ADDENDUM #1 POLICE DEPARTMENT DISPATCH REMODEL BID # 20/21-009 / PWP # WA-2021-153 BIDS DUE NO LATER THAN: 1:45 PM ON FEBRUARY 24, 2021 PUBLIC BID OPENING: 2:00 PM ON FEBRUARY 24, 2021

This addendum is to notify all potential proposers of clarifications made to the Bid documents as stated below.

SPARKS PD DISPATCH REMODEL

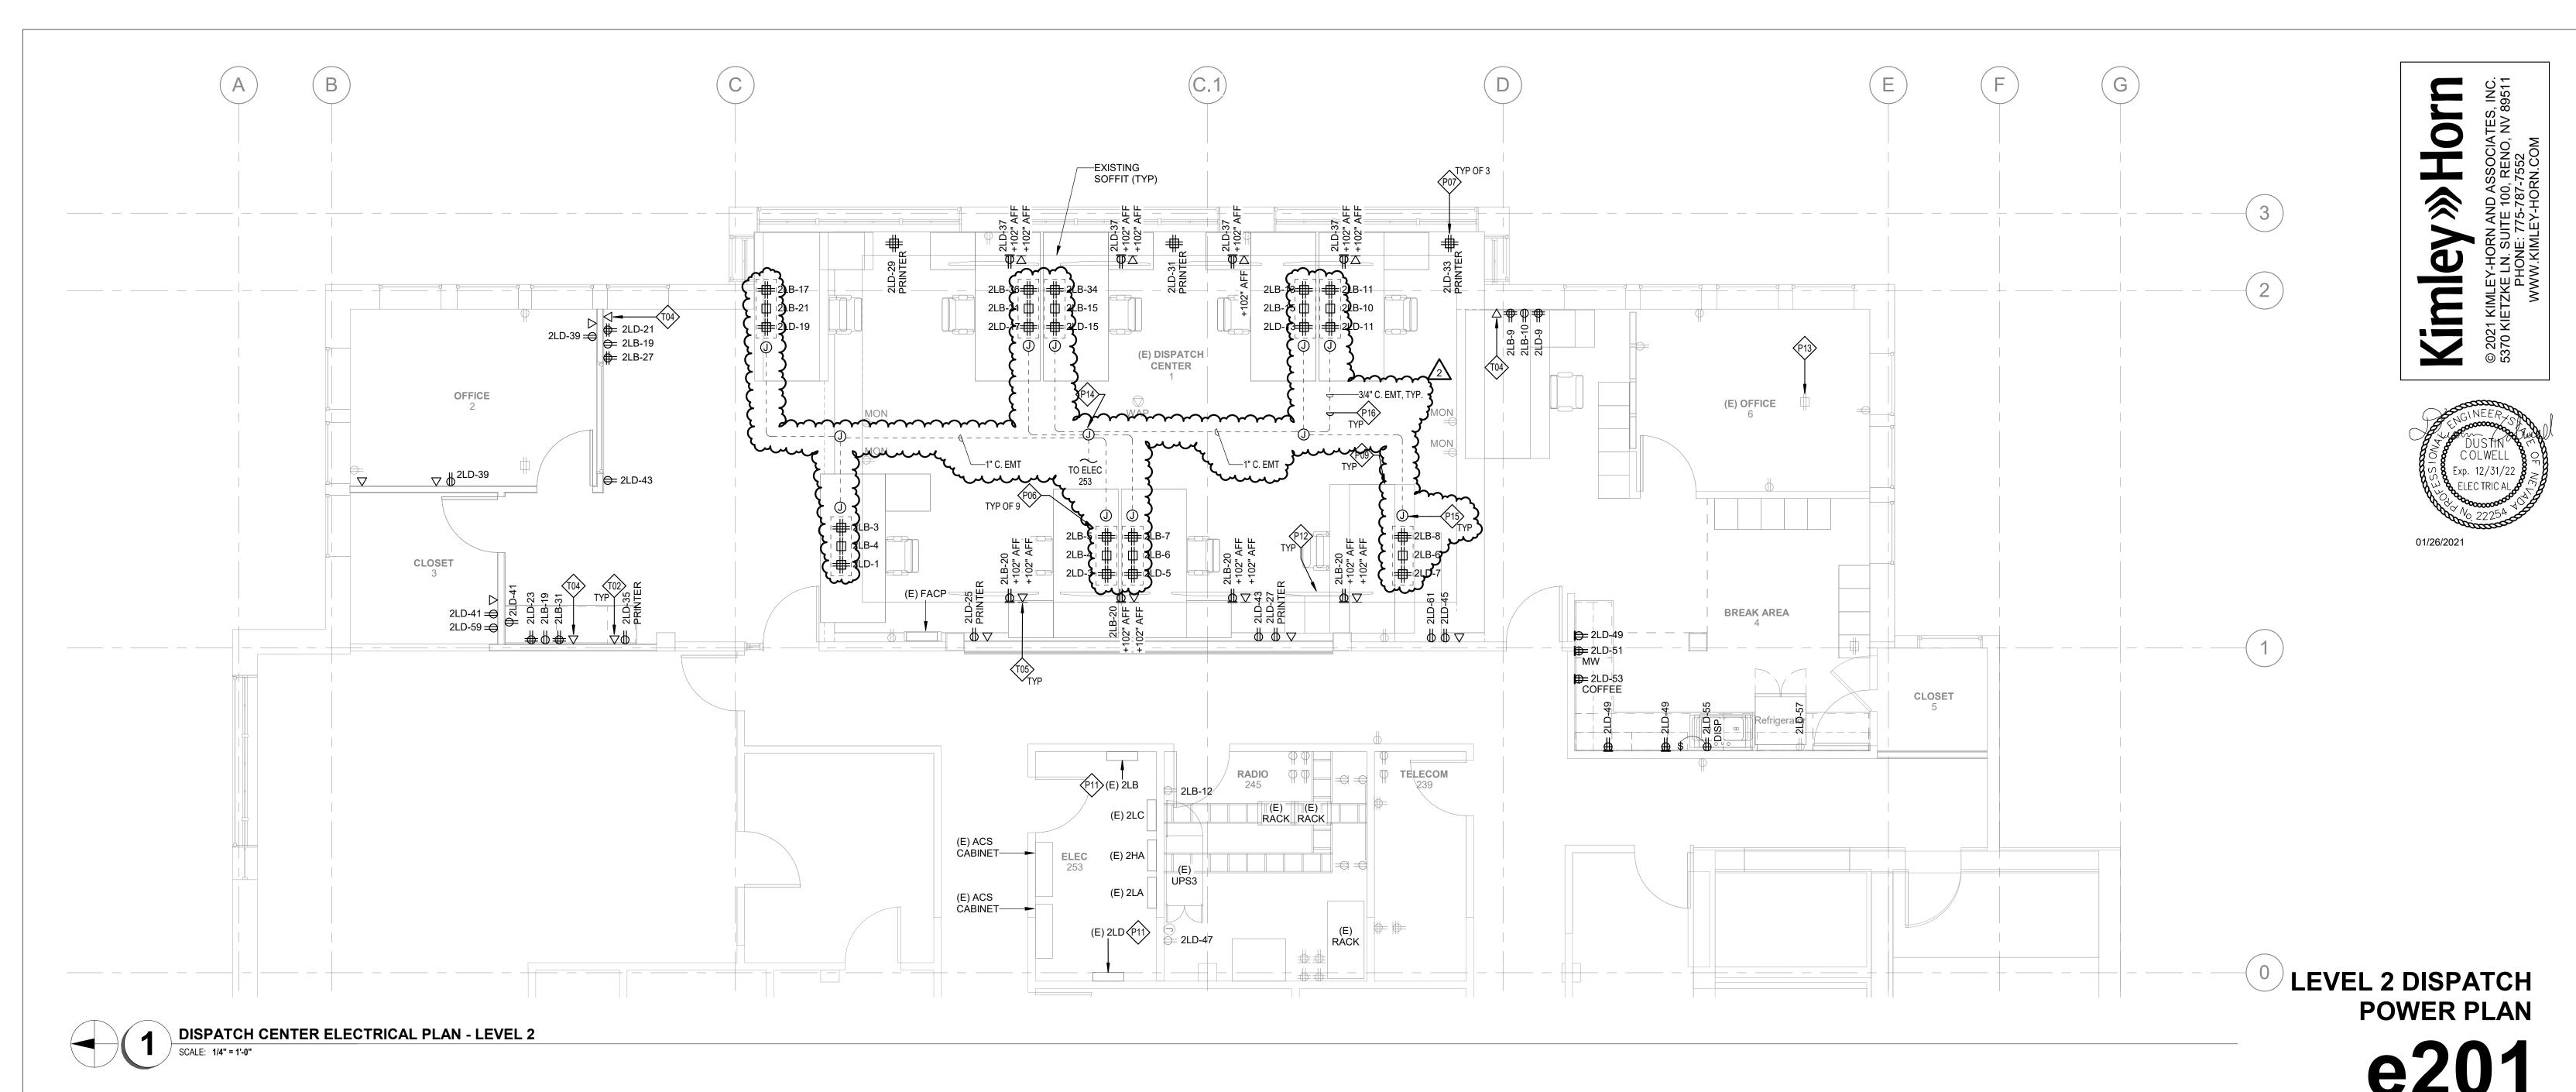
- i. Contractor shall provide R-8 insulation for the ductwork.
 - f. Sheet Keynote P06 on electrical drawing e201 seems to only reference one (1) floor box at nine (9) different locations. However, electrical drawing e201 shows three (3) different floor boxes per the Electrical Symbols on electrical drawing e001. Are we to provide (3) different floor boxes at each of the typical 9 locations, or just (1) quad floor box at each of the typical 9 locations?

- g. Are the floor boxes being mounted to the removable floor panels with a flexible whip?
 - i. The floor boxes are to be mounted to removable floor panel and will serve as a poke thru for the whips to the console mounted wiring devices. See the revised sheet e201 for more details.

- h. Sheet E201 Note P06 specs a 4-gang box with 5 receptacles, 2 data spots and a whip for console furniture. Is there supposed to be multiple floor boxes or are these plugs part of the furniture?

- i. Provide (1) 4-gang floor box per the drawings at each dispatch console, for a total of nine (9) locations that will be fed from below accessible floor. Final receptacle quantities and configuration at consoles to be coordinated with final FF&E (console workstation RFP) submittals. Please see revised drawings for additional clarity. See attached revised Sheet E201.

- i. The plugs are part of the furniture and shall be coordinated with the final FF&E submittals. The floor box is a 4-gang poke-thru.
- i. Electrical Specification 4.1 on Electrical Drawing e002 is requesting a Design/Build Fire Alarm System. Can we have the make and model of the existing Fire Alarm System?

P06 ELECTRICAL FLOOR BOX FOR POWER AND COMMUNICATIONS. PROVIDE HUBBELL CF84G30 WITH ELECTRICAL WHIPS FOR CONNECTION TO OWNER FURNISHED DISPATCH CONSOLE FURNITURE MOUNTED RECEPTACLES. COORDINATE EXACT REQUIREMENTS AND LOCATION WITH FINAL FF&E SUBMITTALS. PROVIDE (1) UPS BACKUP CIRCUIT FOR A QUAD RECEPTACLE, (1) UPS BACKUP CIRCUIT FOR A DUPLEX RECEPTACLE, AND (1) NORMAL CIRCUIT FOR A QUAD RECEPTACLE FOR NON CRITICAL LOADS. POKE-THRU SHALL BE MOUNTED TO RAISED FLOOR TILE. CONTRACTOR SHALL ROUTE WHIPS VIA POKE-THRU AT THE LOCATIONS SHOWN AND PROVIDE (10) FEET OF FMC TO PROVIDE FLEXIBILITY FOR LOCATING THE POKE-THRU IN THE DISPATCH CENTER. COORDINATE FINAL CONDUIT ROUTINGS WITH OWNER. TELECOMMUNICATIONS DEVICES, CABLING, AND TERMINATIONS FOR CONSOLES BY OTHERS.
